**Report: TAB REPORT  
Function: Test, Adjust, & Balance  
Date: 05/25/2023**

**PROJECT  
05-22-23 FREDDY'S OGLETHORPE, GA**

RKS Ventures, Inc.  
9340 E Central Ave  
Suite A  
Wichita, KS 67206

RTU-1  
05/26/2023

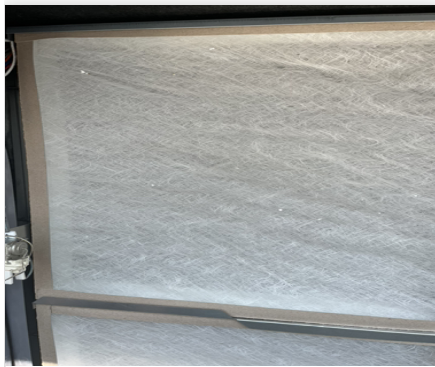
**Issue Name :** RTU Temporary Final Filters Still Installed.  
**Description :** Both RTUs still have throwaway construction filters installed.  
 Recommend correct pleated final filters are installed.
